14 May 2026

Our ref: RL-01-2509-01

RE: Development Application Independent Review – Stormwater Matters - 346-350 Old Northern Road, Castle Hill (PPSSCC- 592)

Figure 4 1% AEP flood extract - Draft Urban Overland Flow Study (THSC, 2024) (Site outlined)

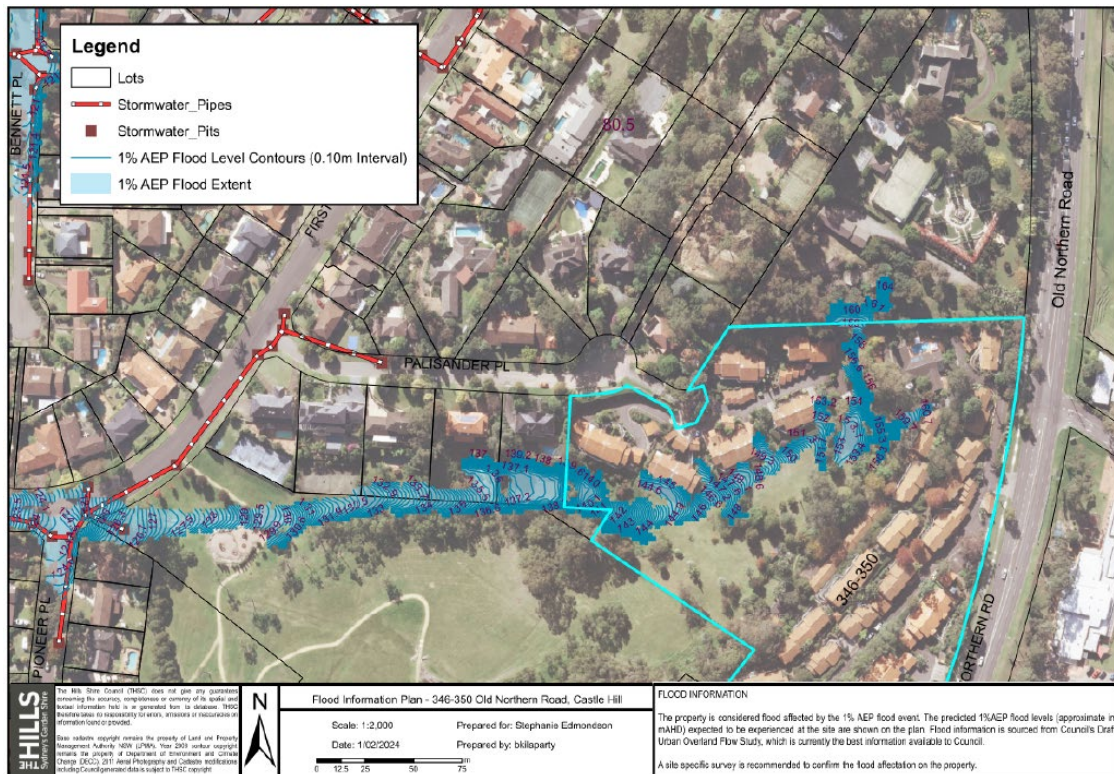
Council has completed a *Draft Urban Overland Flow Study* (THSC, 2024) (the **OLFS**) for the locality. An extract from the draft report provided by Council to Rhelm is shown in **Figure 4** shows the site as being affected by overland flow flooding in the 1%AEP design flood event and depicts overland flow commencing just upstream of the site in the adjacent property to the north (352 Old Northern Road) and then flowing south and south-west through the site to Pioneer Place Park. It is understood that the study was completed using Australian Rainfall and Runoff (2019) Version 4. (Ball et al, 2019).

Figure 5 Site Plan (Source: Cox Architects Revision 3)

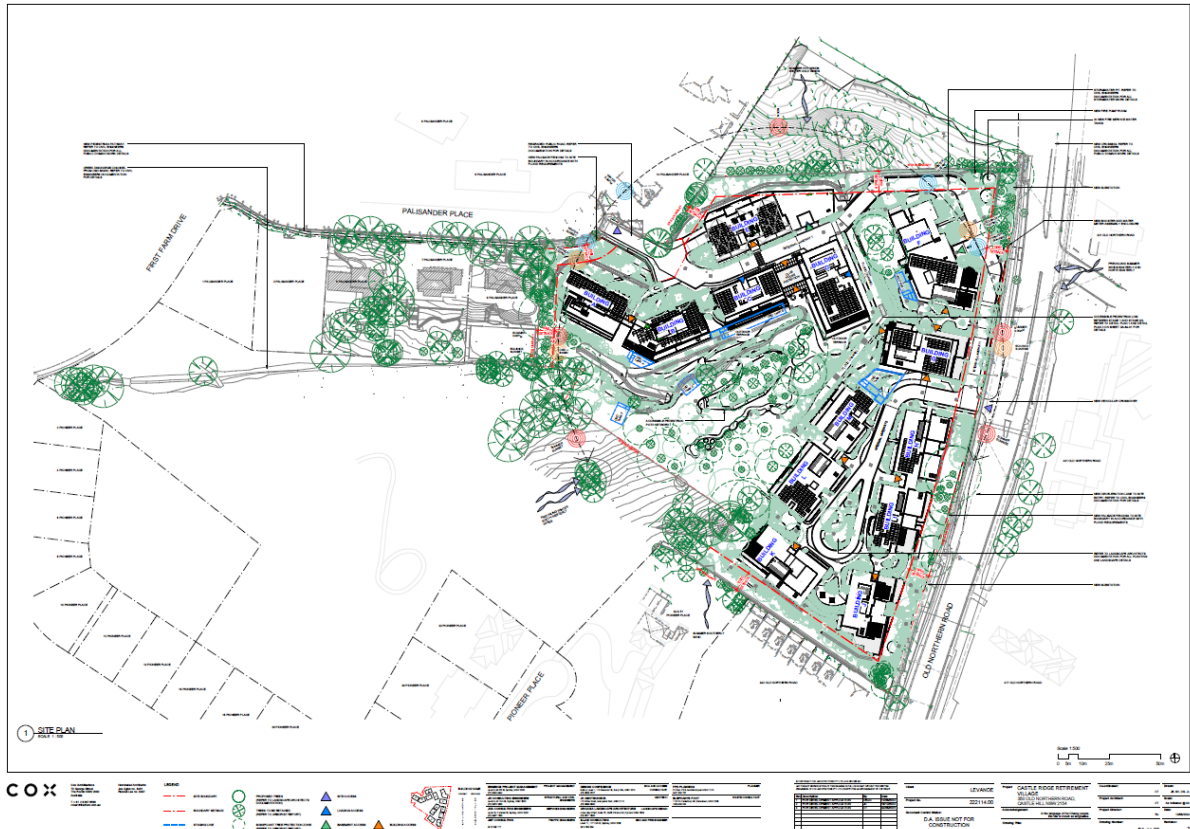
- ***Maintenance access issues for proposed OSD facilities*** - The JN Consulting drawings Revision 9 dated 29 August 2025 drawings indicate six OSD tanks (these are also shown in the Cox Architecture drawing set). However, there is insufficient information to evaluate how each tank will be accessed and maintained. JN Consulting Drawing C0100 depicts the stormwater site plan whilst Drawing C0400 presents the grading site plan. With the majority of the OSD tanks located on the far side of the proposed buildings from the internal road network (or within the open channel itself), vehicular access for maintenance trucks to allow safe inspection required and to periodically clean each tank has not been adequately accounted for in the design. Additional plans are required or existing plans should be updated to show how access will occur (ideally showing a hardstand area that will not block traffic). An OSD maintenance schedule is also required to identify frequency of maintenance, noting that the maintenance will need to be relatively frequent given the inclusion of water quality treatment cartridges within the OSD tanks to meet water sensitive urban design requirements (noting that it has not been demonstrated that the provisions of Chapter 6 of the *State Environmental Planning Policy (Biodiversity and Conservation) 2021* have been met).

Figure 6 Stormwater Site Plan (Source: JN Consulting – Revision 9)

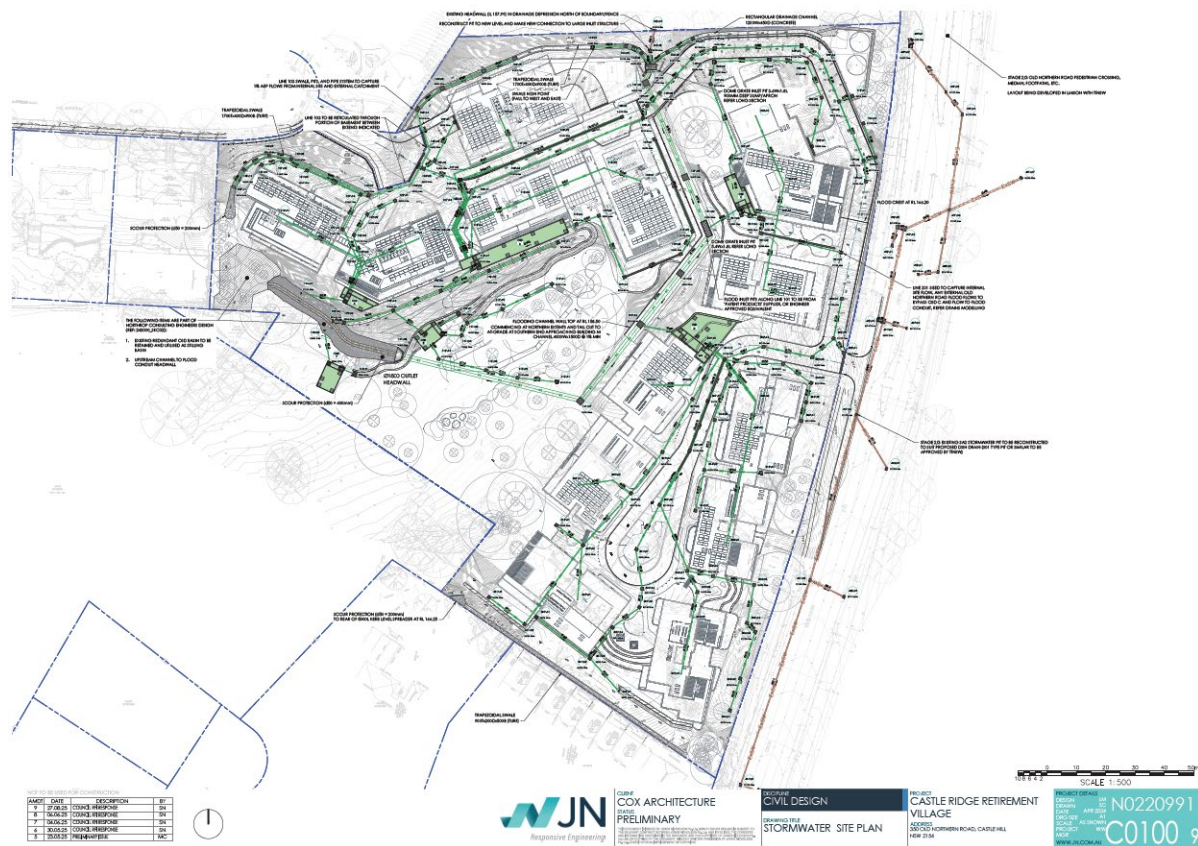
In the civil design drawing set, Drawing No. C0100 (reproduced as **Figure 6**) depicts the stormwater site plan. There is an existing headwall capturing runoff from 352 Old Northern Road, north of the site, which is to be connected to a 'flood conduit' (see Drawing C0300) traversing the site (a stormwater drainage line, referred to as Line 01 on Drawing C605). The flood conduit is effectively an upgrade of the existing 1.2m diameter pipe culvert to a 1.8m diameter pipe culvert with the flow from this discharging flow into a rock riprap/reno mattress-lined open channel (described further below) and then into a stilling basin. Flow will then be discharged into an open channel located along the boundary with 9 Palisander Place and Pioneer Park. Note that the drawings show a section of the flood conduit being a 1.2 m diameter pipe, but the report says the pipe will be upgraded to a 1.8 m diameter pipe. Clarification of the proposed upgrade is required (and may necessitate a drawing update).

- **Unrepresentative flood impact assessment** – The proposed scenario incorporated in the TUFLOW modelling does not align with the latest JN Consulting civil engineering drawings Revision 9 dated 29 August 2025 (Job Number N0220991) (noting that these drawings were completed four months after the FIA report). Therefore, the application is not sufficient to adequately assess in accordance with DCP 2012 – Part C, Section 6 Flood Controlled Land (specifically General Development Controls (a)). And (THLEP, 2019) Clause 5.21. An updated hydraulic assessment (including consideration of contemporary methods as outlined at the next point) is required to address these inconsistencies such that the actual effects of the proposed development can be properly considered. The outcomes of such an assessment might result in an amendment to the proposed drainage arrangements, architectural plans and/or the internal road network.

- **Issues with proposed drainage and channel modifications required to support the development** –
 - The proposed flood conduit illustrated in JN Consulting drawing C0300 with corresponding cross-sections in drawings C0556 / C0557 depicts Line 101 adopting a 1.2m diameter through to 1.8m diameter pipe conveying surface runoff from 352 Old Northern Road, north of the site before discharging flow into a rock riprap mattress-lined open channel. Above the flood conduit, is a proposed surface overflow flood channel with a flood wall, indicated as 4m minimum width, with the height of the flood wall not clearly defined (but appears to be up to 1.5 m). The

structural integrity of the ‘flood wall’ and overland flow channel’s capacity to convey the Probable Maximum Flood has not been clearly defined and should be clarified given the reliance of the development on these features to manage risk to property and risk to life. As outlined above, the drainage network sizing is likely needed to be increased to reduce flood hazard on the internal road network.
